T10/97-181r0

Subject: Presentation on LVD results

Ten Problems that Asymmetrical Drivers with Bias Voltage Termination Have, that are not there for Symmetrical Drivers with No Bias Voltage Termination

Figure 1

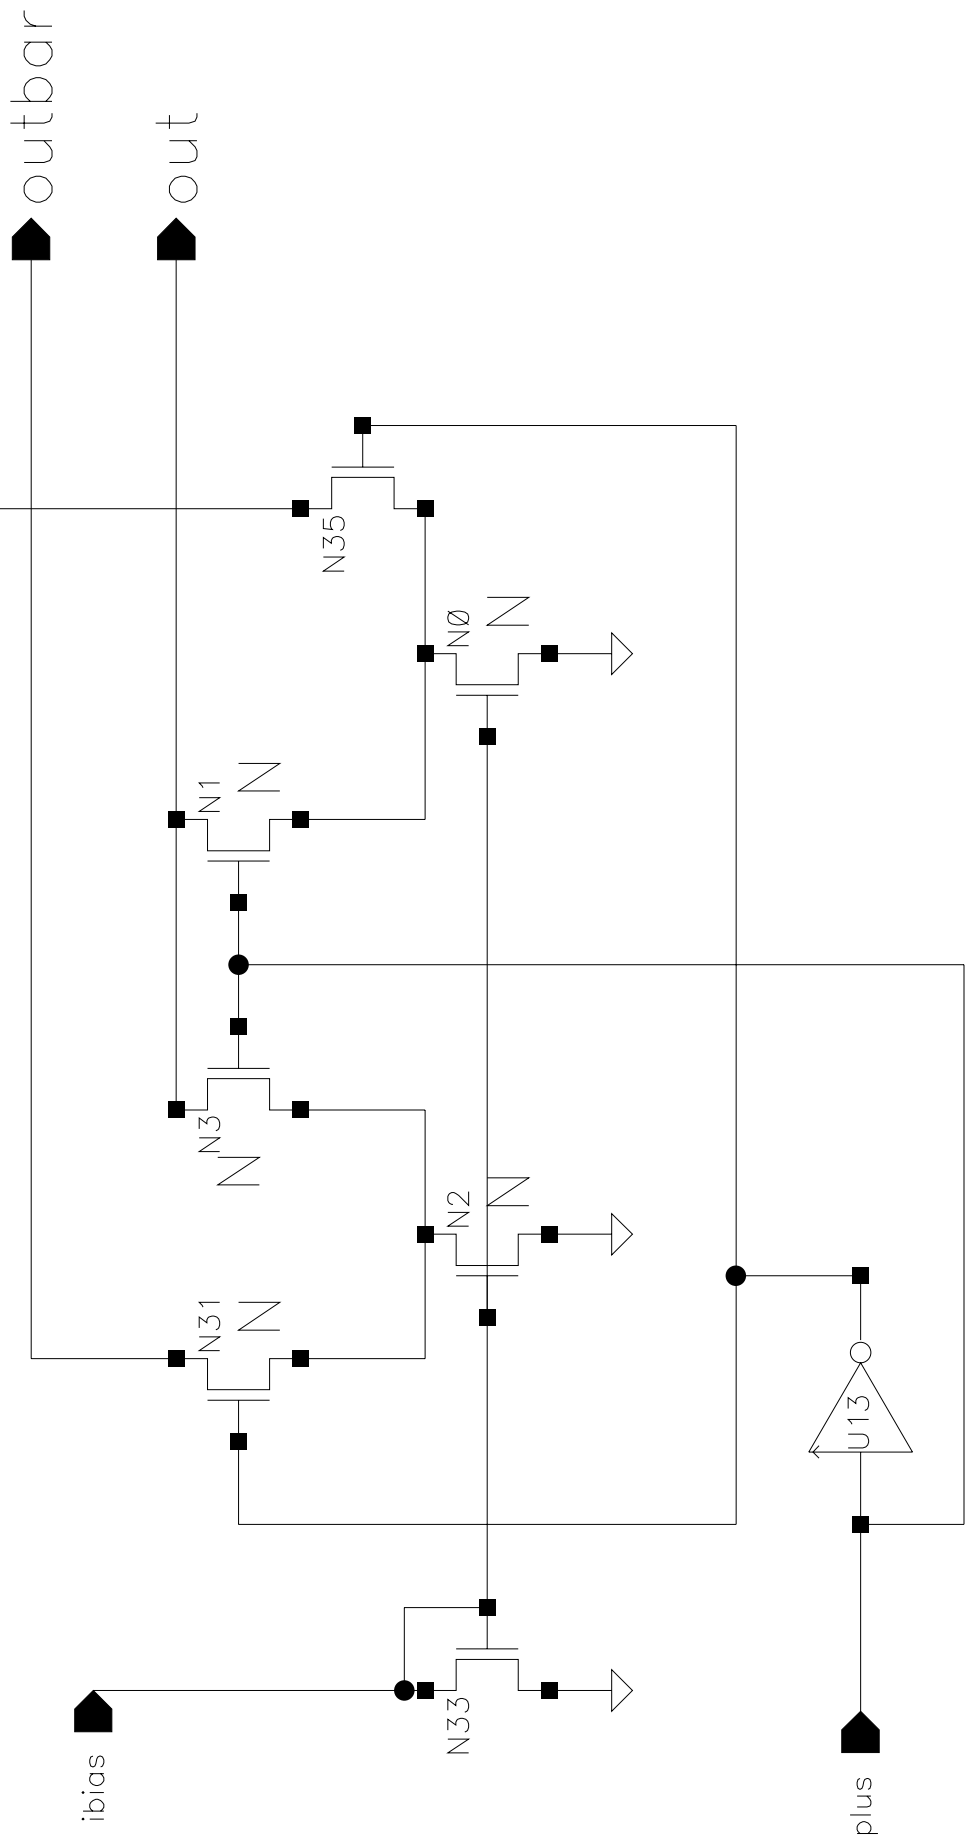
- 1.3 Unequal output currents creates greater RFI or EMI (radio frequency interference, electromagnetic interference). This has not been measured.
- 1.4 For a good current mode design (this doesn't apply to voltage mode drivers), extra current or power is needed to create lower impedance reference voltages to bias the current source transistors. Or, you need extra power to have a separate bias distribution system for the offset current. The charge coupling from gate to source/drain overlap capacitance is unequal as the outputs switch back and forth from high current to low current, and the unequal charges, create a short term accuracy problem (unless you have a low impedance bias voltage driving all your current sources). Also, for the offset current

mirror transistors, they turn on & off, and that couples into the bias voltage with a greater effect than the overlap capacitances do. See figure 1. This applies only if you try to do a really good current mode output design.

Domain for Driver Assertion and Negation Levels

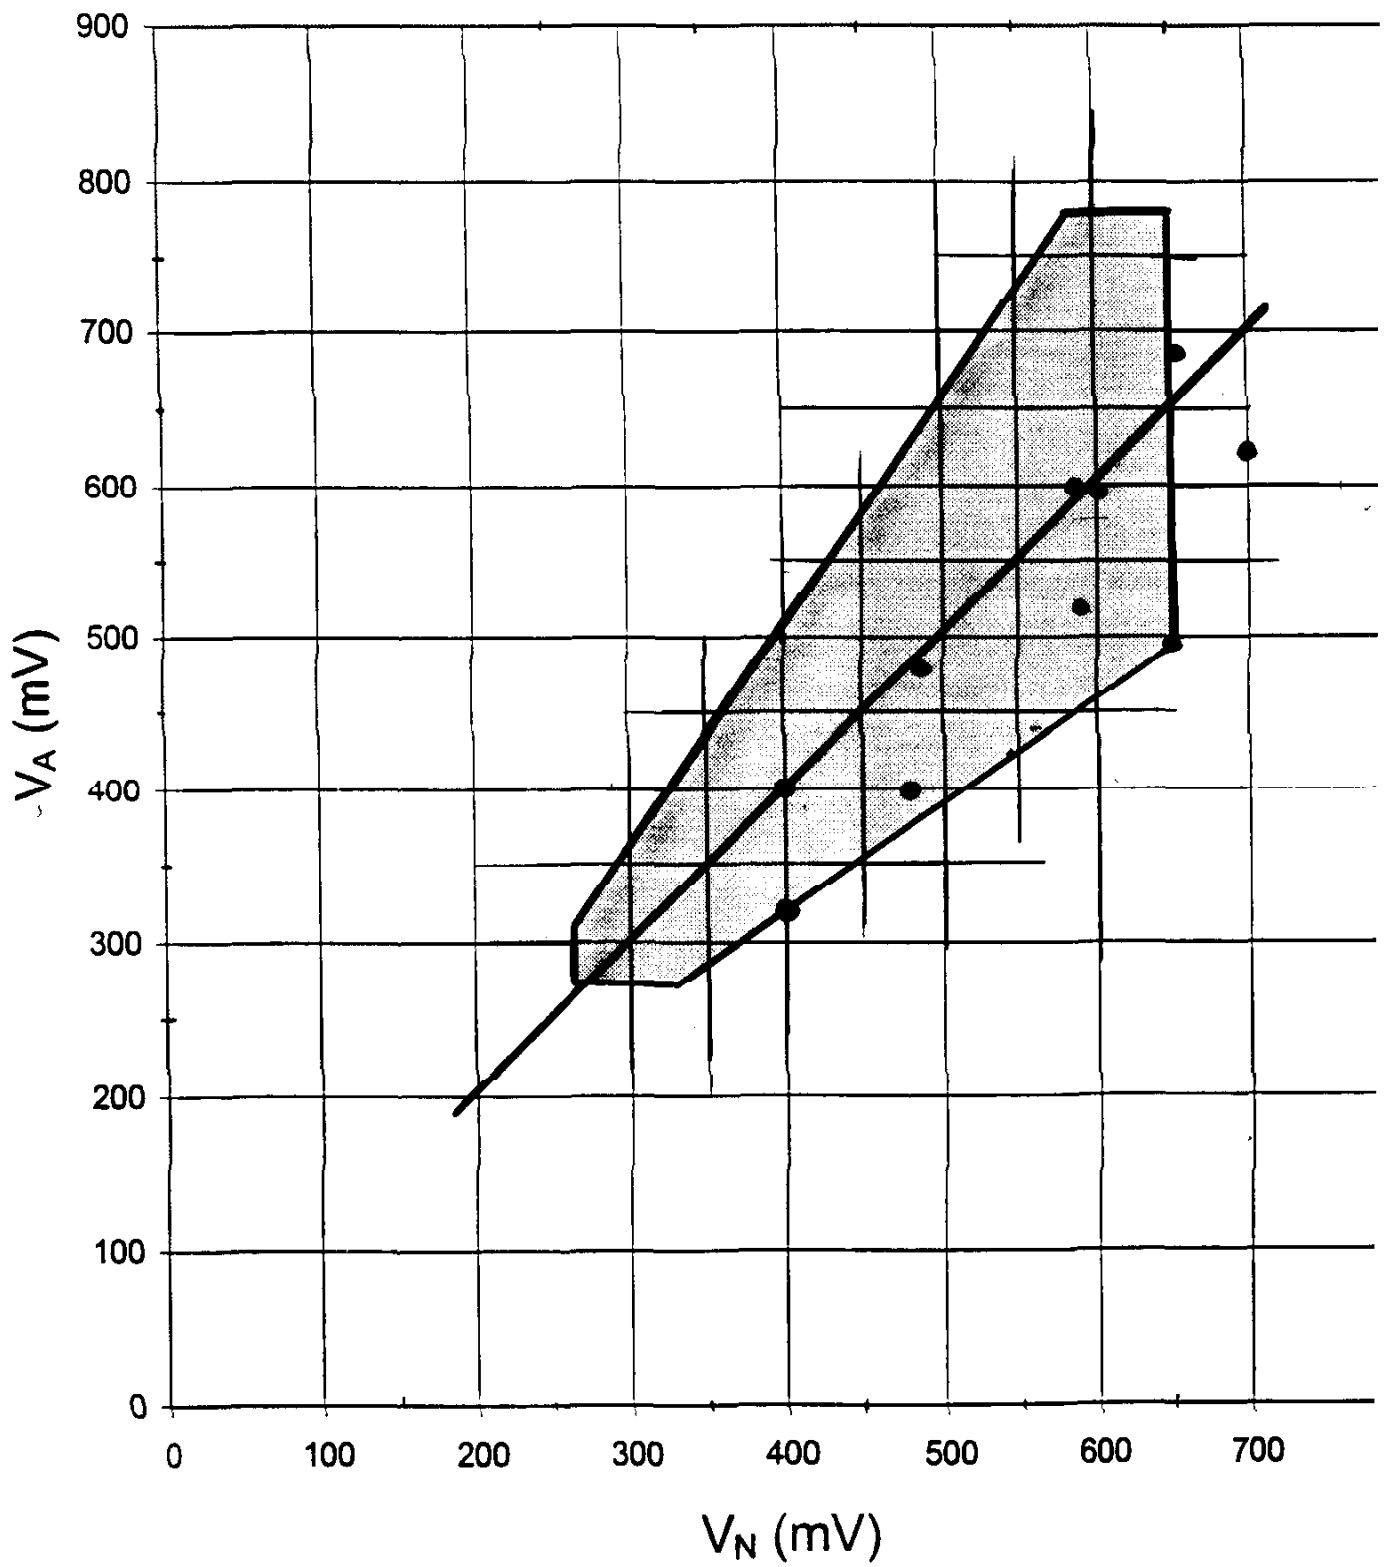
For this point with vbias = 125mV,
 Va=(.3415-0.0125=0.329 volts)
 Vn=(.3865+0.0125=0.399 volts)

For the above point with vbias = 125mV

$$V_a = .3415 - 0.0125 = 0.329 \text{ volts}$$

$$V_n = .3865 + 0.0125 = 0.399 \text{ volts}$$

Figure 4

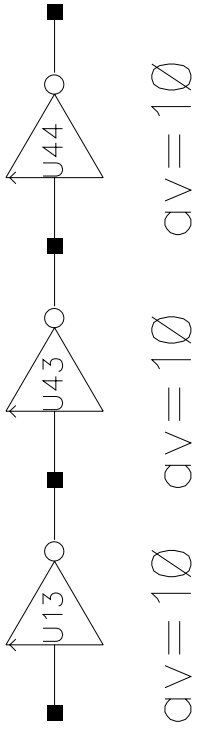
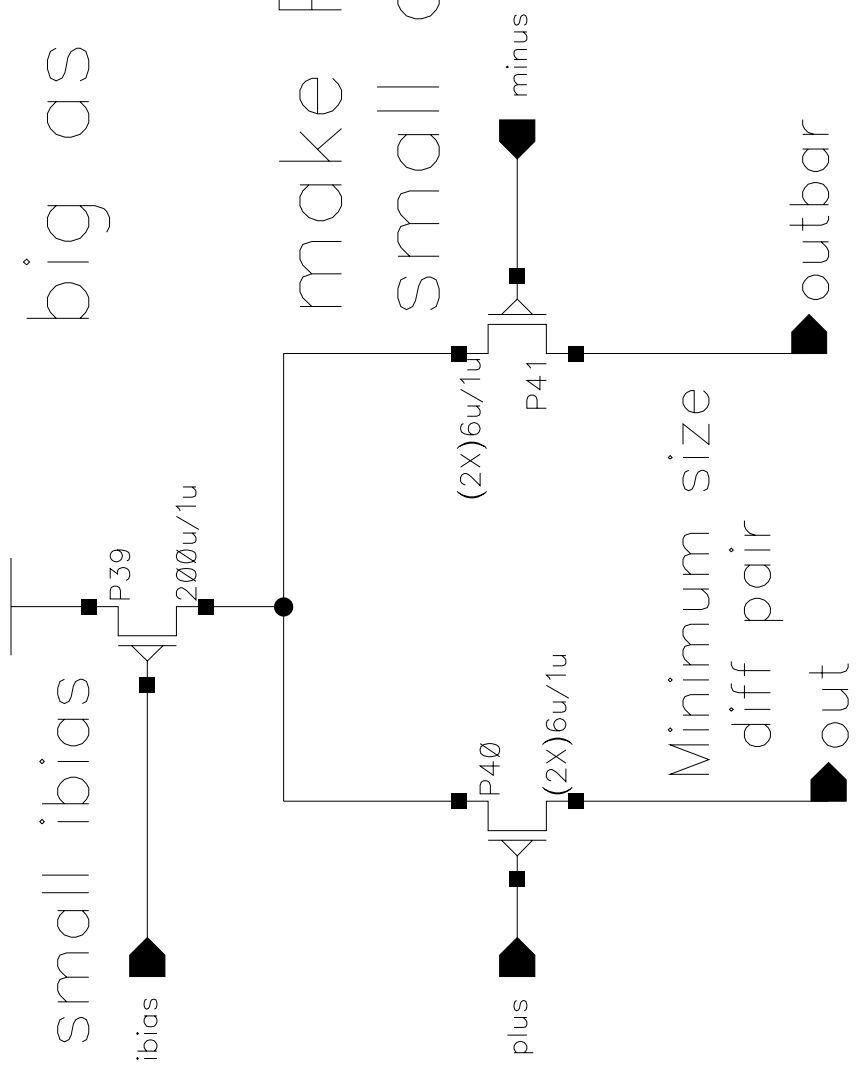
to make I/gm as big as possible

make P40 & P41 as small as possible
